Deficiency Letter Response of New York State Electric & Gas Corporation

Columbia County Transmission Project
Towns of Chatham, Ghent and Stockport
Columbia County, New York

Submission to
State of New York Public Service Commission

Response to June 22, 2012 Deficiency Letter

Figure 1. Ring Bus at Valkin

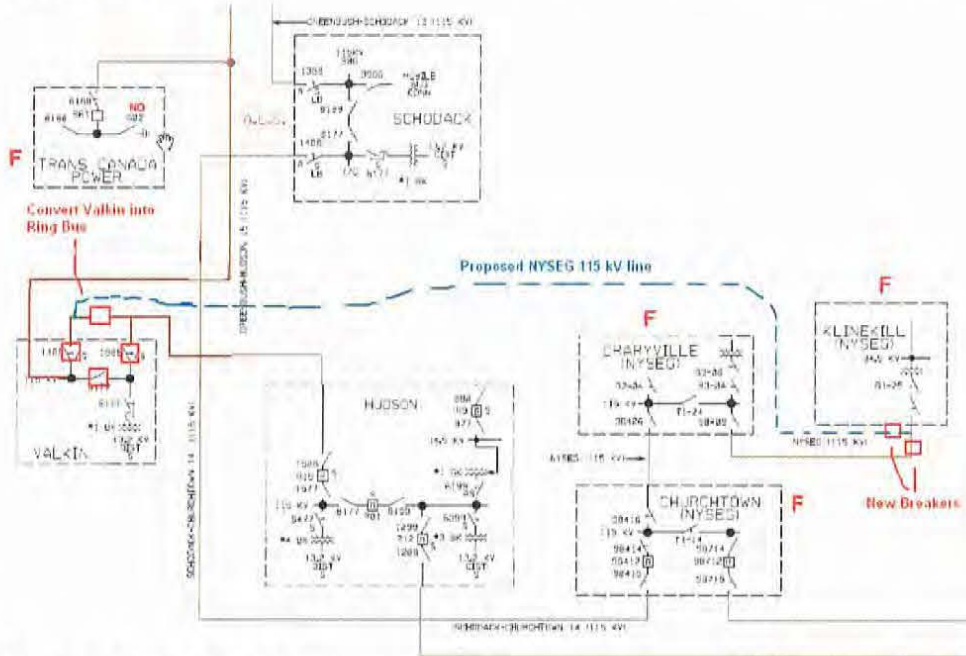
Option 1 – 115 kV Line Between Valkin and Klinekill (4-breaker Ring Bus)

There are two 115 kV taps into Valkin: #15 line tap and #14 line tap. Only one of the lines serves Valkin at a time. Under normal conditions, #14 tap is open. There is an automatic throwover scheme at Valkin that transfers Valkin substation from #15 line to #14 line when there is a fault at #15 line. In the new design of the Valkin substation, the connection to #14 line will be eliminated, and the tap to #15 line will be used to make #15 line loop in and out of Valkin substation as shown in Figure 1. Although the ring bus is shown to have four breakers, enough room is allocated for a future fifth breaker. Ring bus will provide three 115 kV sources into Valkin as opposed to two sources in the existing configuration. These sources are north and south section of #15 line, and Valkin-Klinekill line.

Figure 2. Ring Bus at #15 line ROW

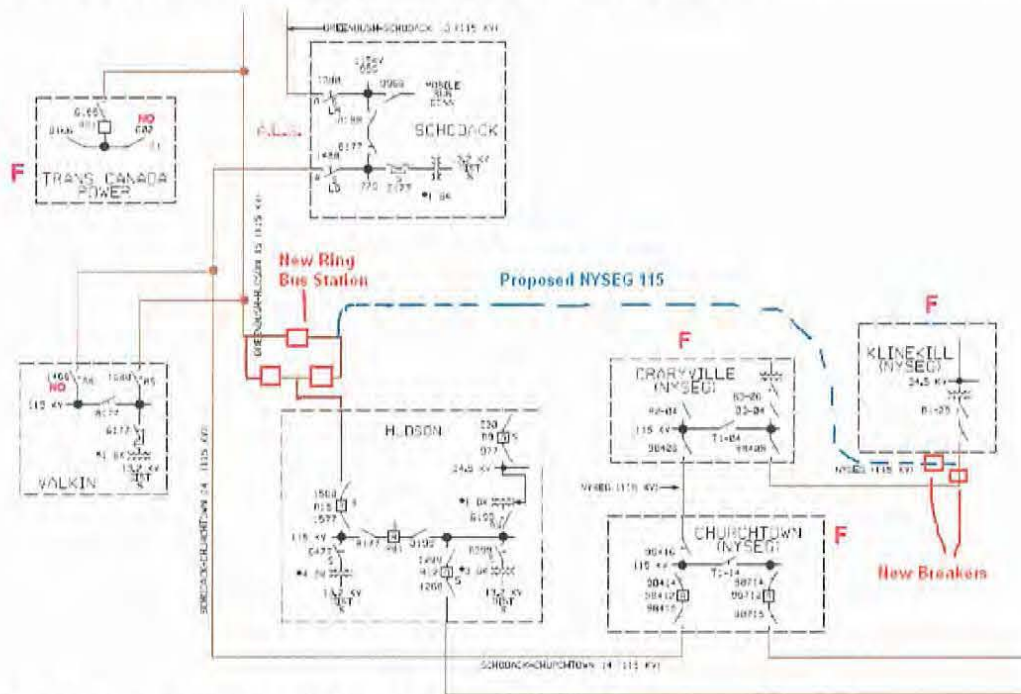
Option 2 – 115 kV Line Between Valkin and Klinekill (3-breaker Ring Bus), Recommended

Instead of modifying Valkin substation, the new 115 kV Valkin-Klinekill line will terminate at #15 line. This configuration will require three new breakers and a new station in the 115 kV ROW from Greenbush to Hudson as shown in Figure 2. From a reliability perspective, Options 1 and 2 are comparable since they both sectionalize #15 line. This option does not require any changes to the Valkin station.

Since Option 2 involves tapping #15 line at the ROW, there is no need to build the line through National Grid franchise territory in Kinderhook county. Instead the line can be built through NYSEG franchise territory in Ghent county as shown in Figure 3. And the distance will be similar to the Valkin-Klinekill distance. The actual substation site and line routing are flexible, and may be adjusted to reflect permitting and cost considerations.

Figure 5A.36
Temporary Access Bridge

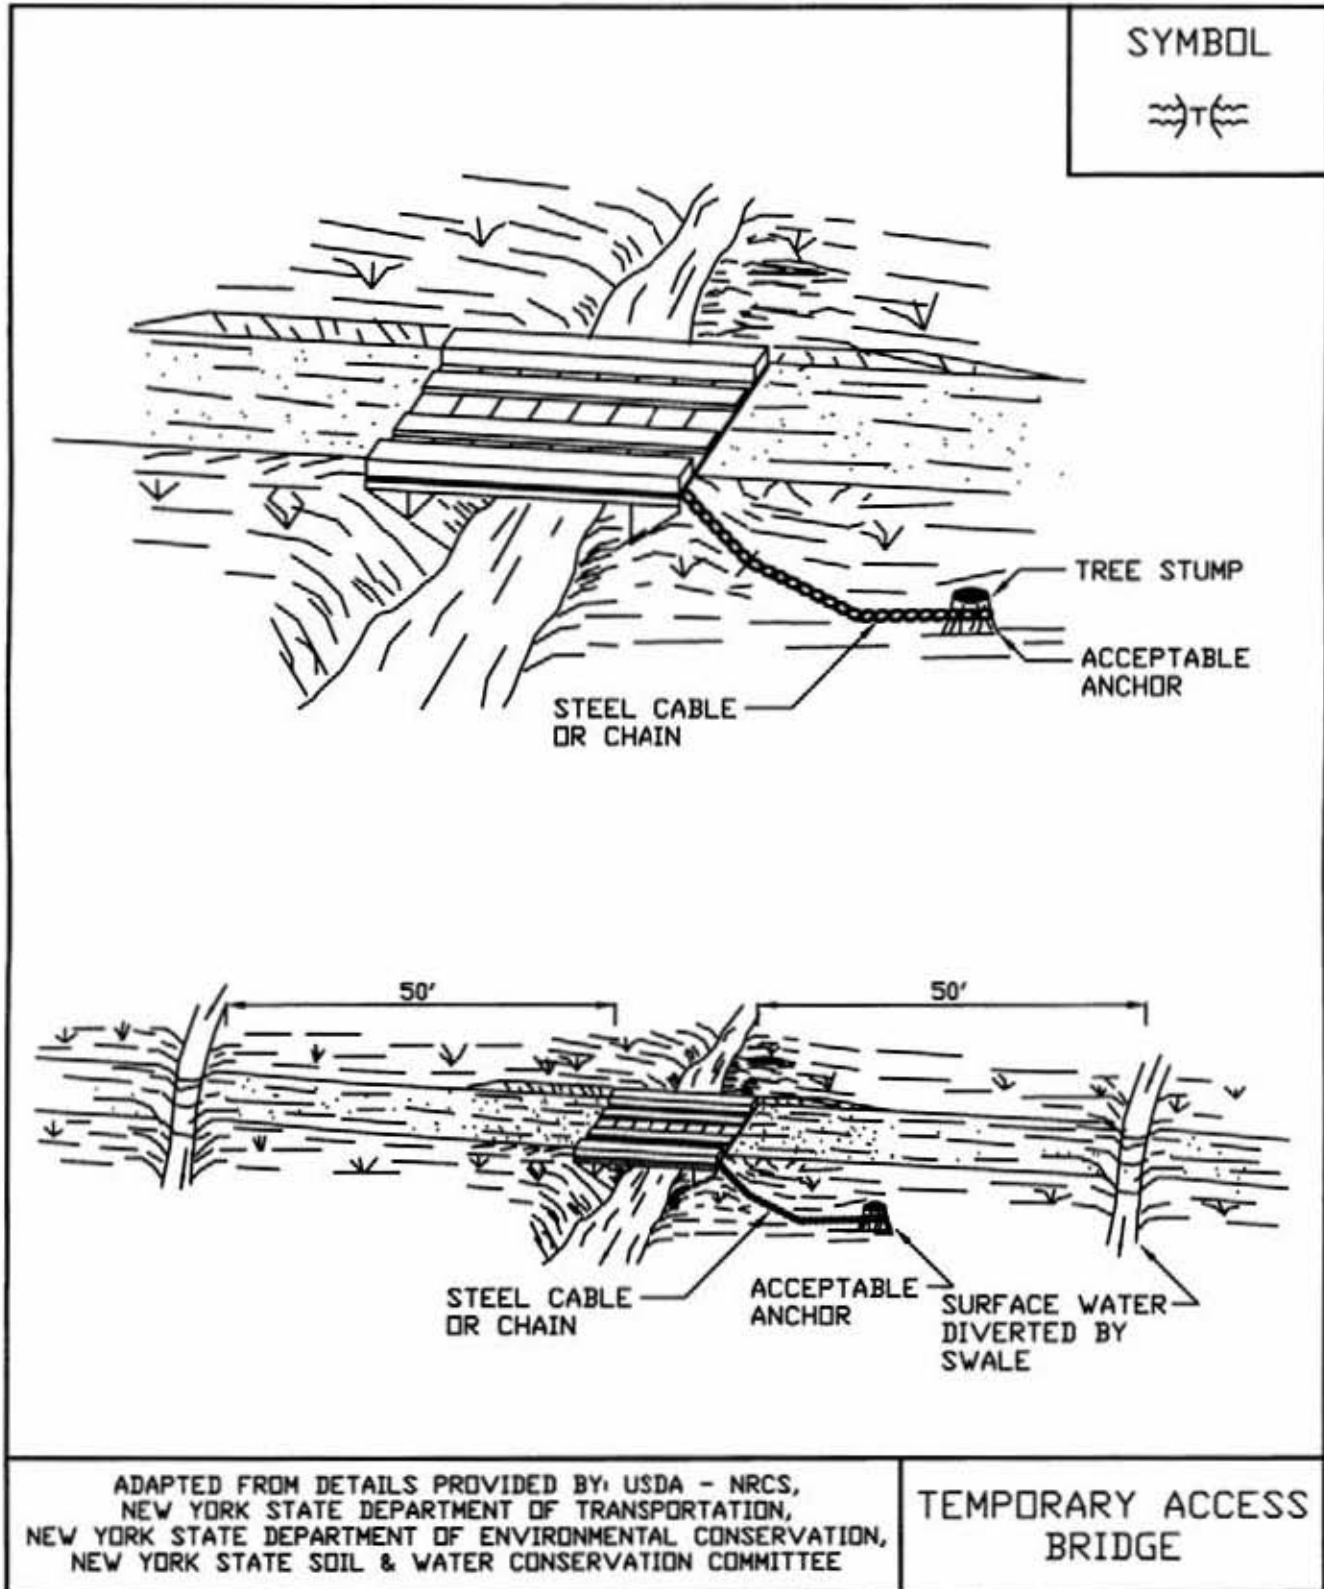
Temporary Access Bridge (Figure 5A.36 on page 5A.84)

**Figure 5A.37
Temporary Access Culvert**

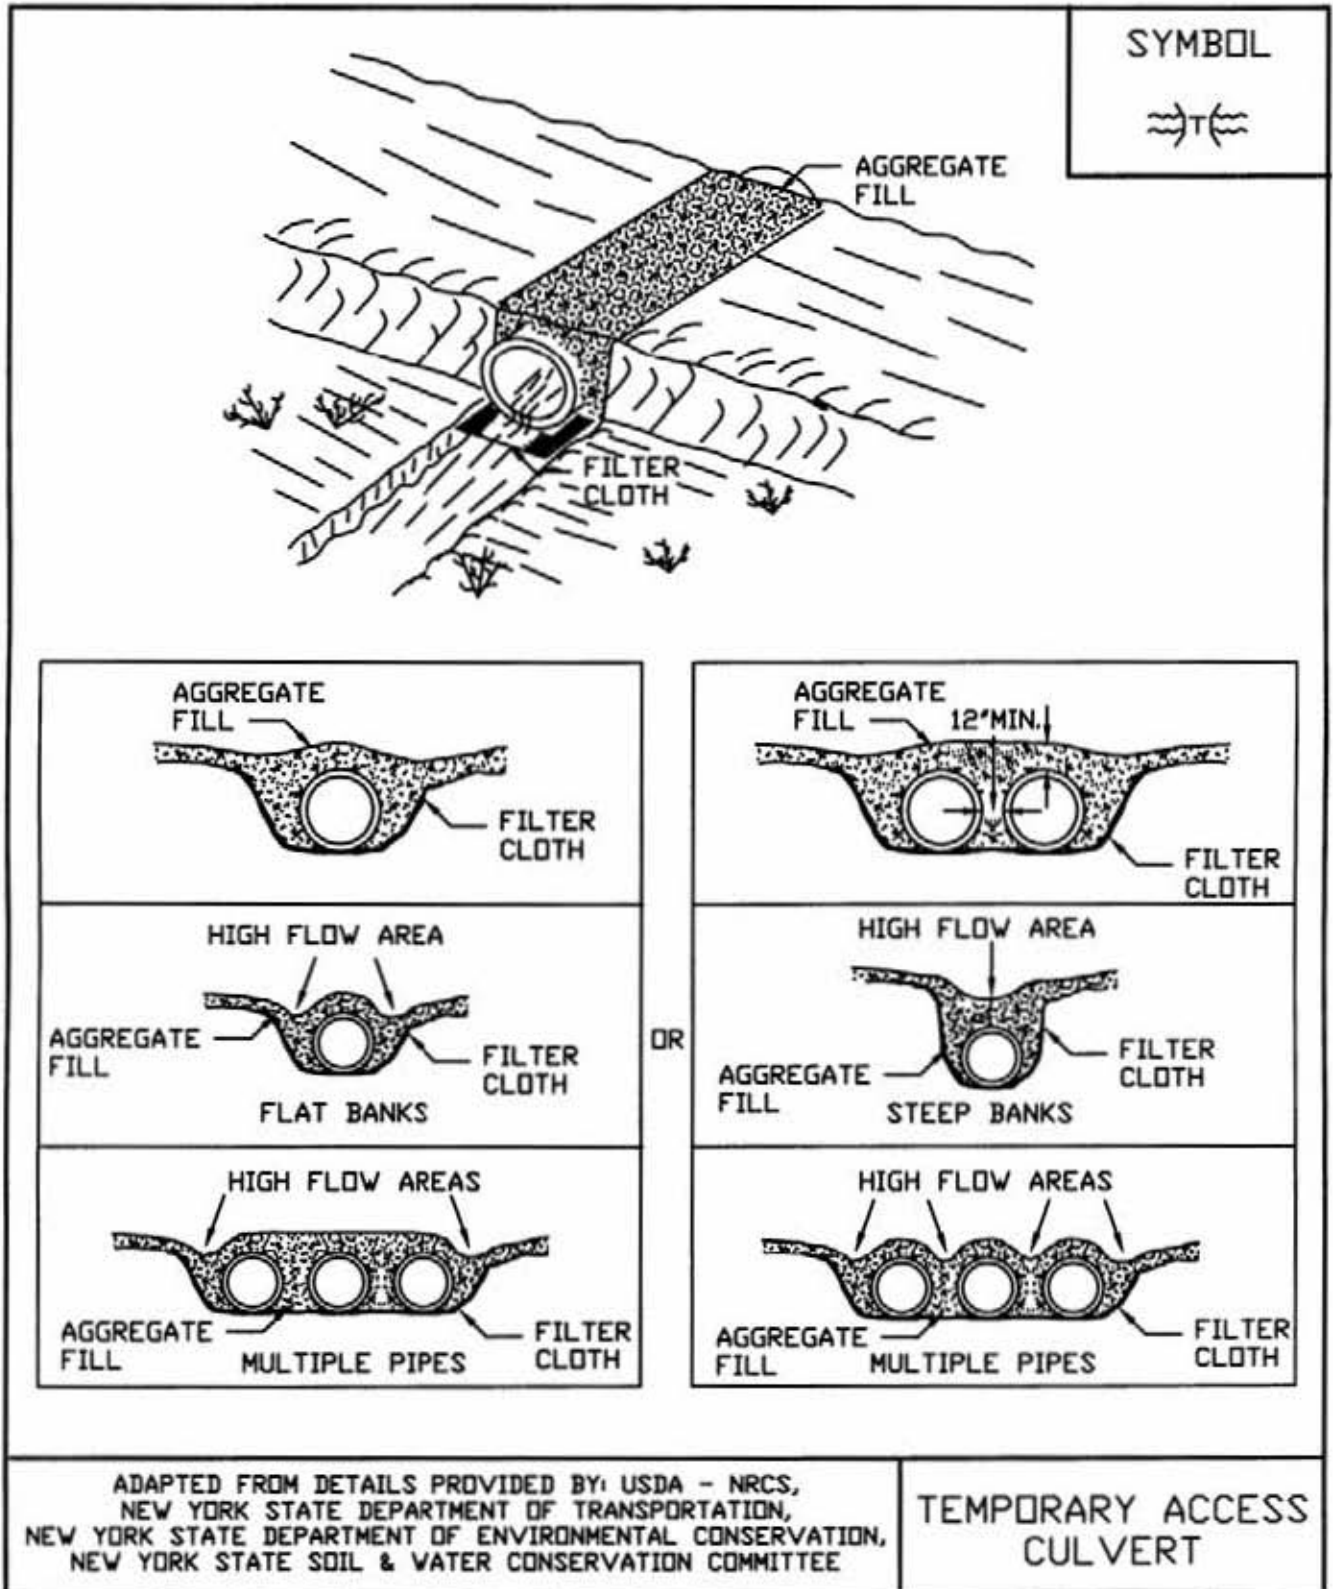
Temporary Access Culvert (Figure 5A.37 on page 5A.85)

**Figure 5A.38
Temporary Access Ford**

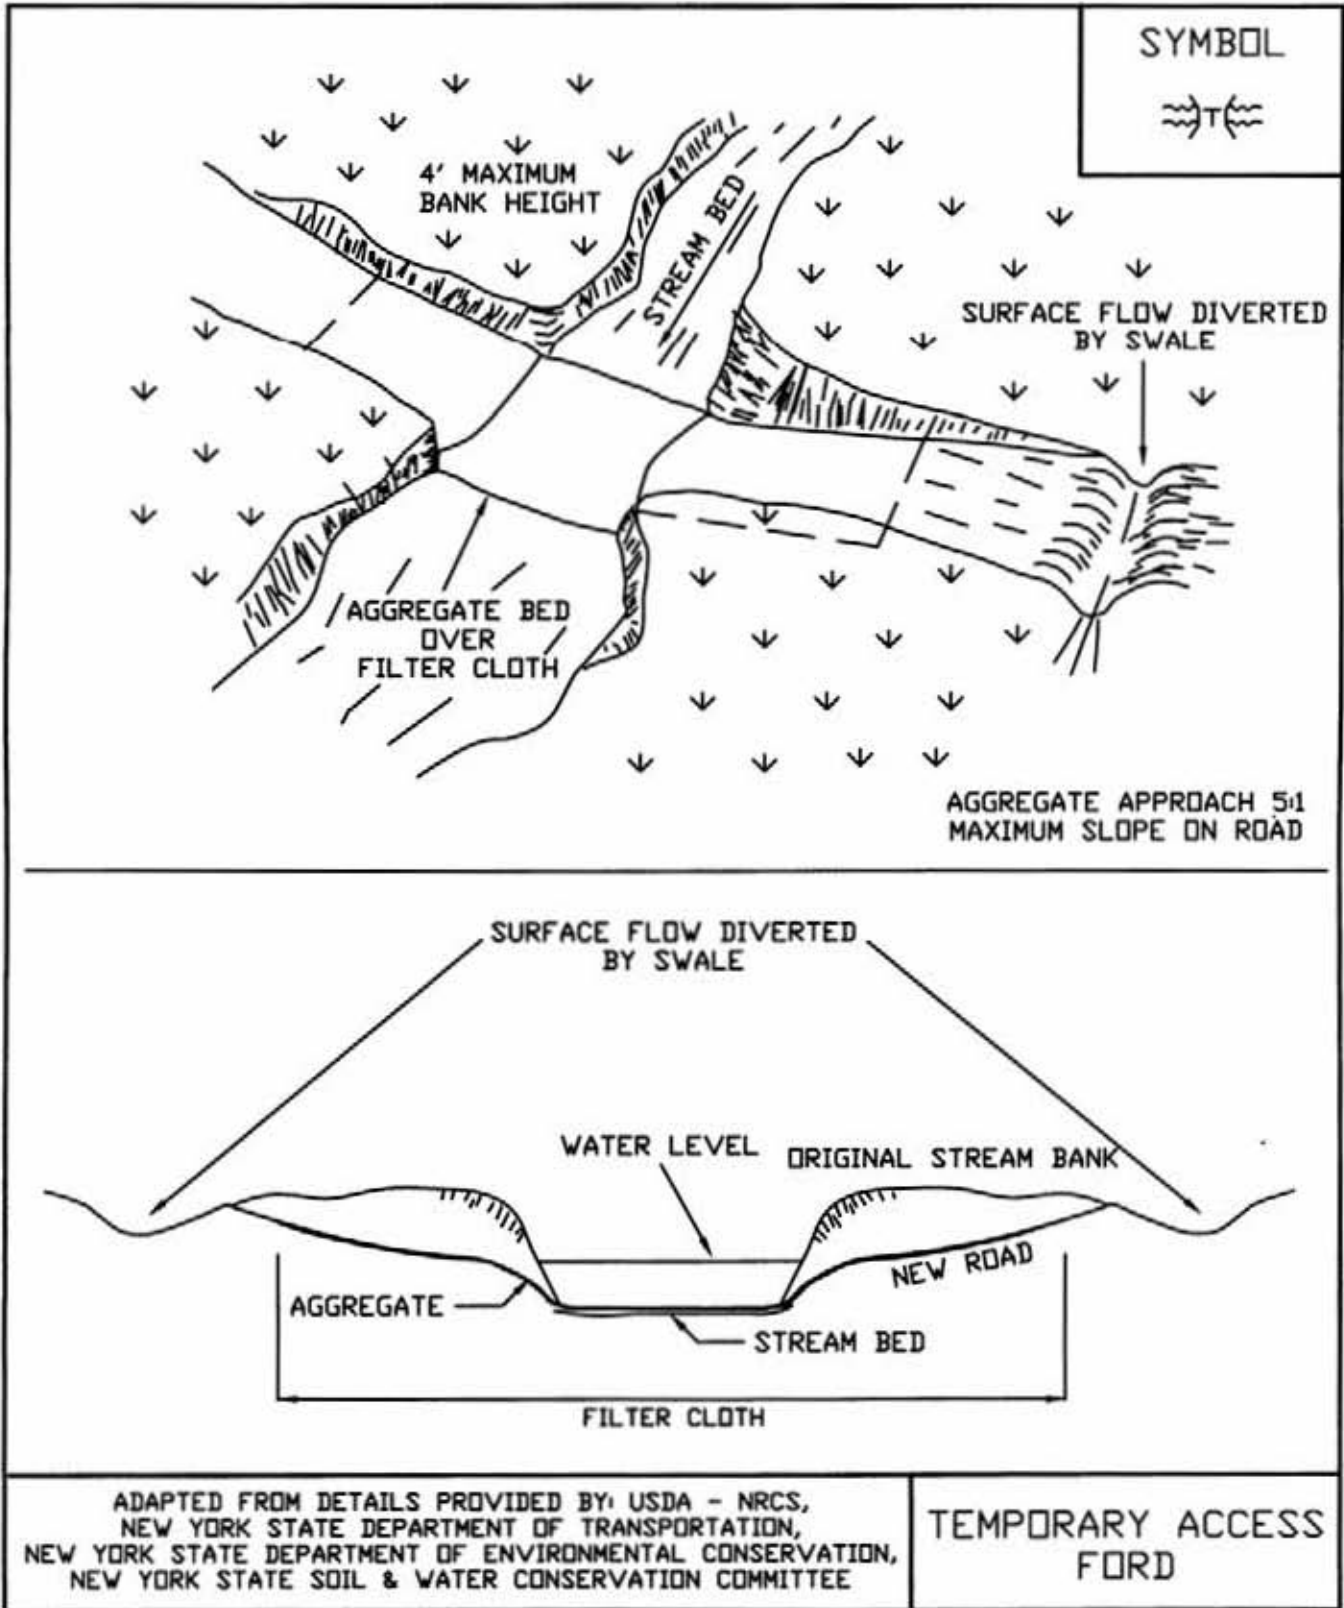
Temporary Access Ford (Figure 5A.38 on page 5A.86)
